NOTICE OF DETERMINATION OF A DEVELOPMENT APPLICATION

Determination Number:
SPP-17-00031

Property Description: Lot 63 DP 30186 H/N 84 Tallawong Road ROUSE HILL

Development: Integrated development including demolition of an existing dwelling and outbuildings, Torrens title subdivision to create 3 super lots and construction and dedication of public roads, and the development of proposed Lot 1 in the subdivision for 2 shop-top housing buildings containing a total of 117 units over 8 ground floor commercial tenancies with 127 residential car parking spaces, 24 commercial car parking spaces and 24 visitor parking spaces in 2 basement levels with associated stormwater drainage works and landscaping

TYPICAL STREET TREE PLANTING DETAIL
SCALE 1:20 @A1

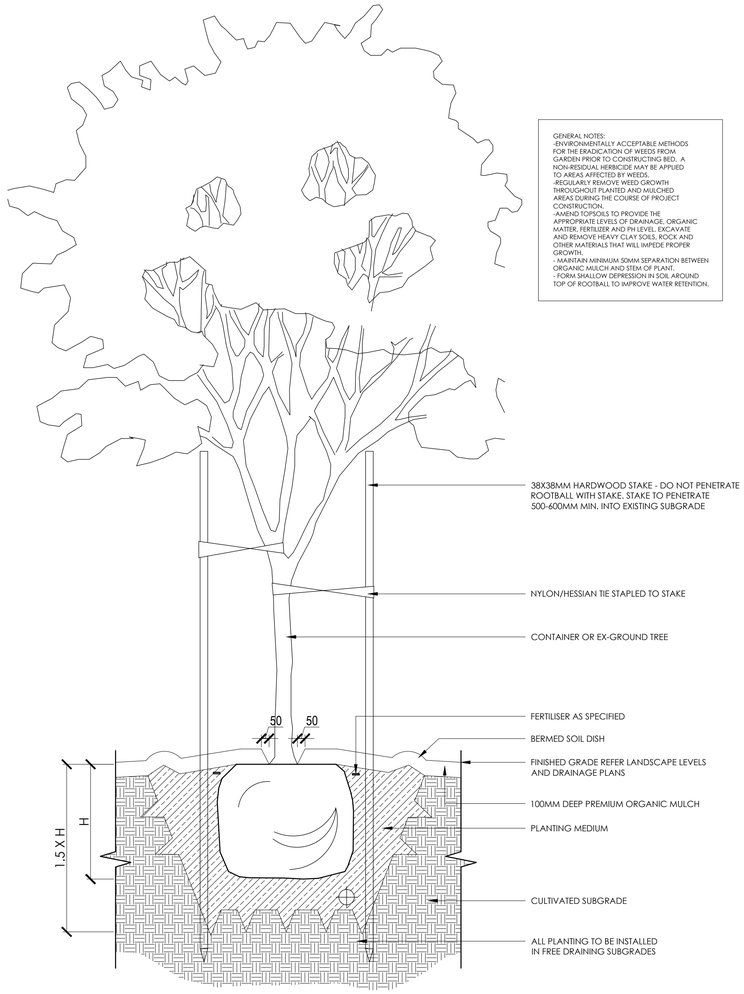
i. The street trees to be planted are to have an approximate spacing of 8 m.

iii. Planting and maintenance details including the use of root directors shall be installed to manufacturer's directions
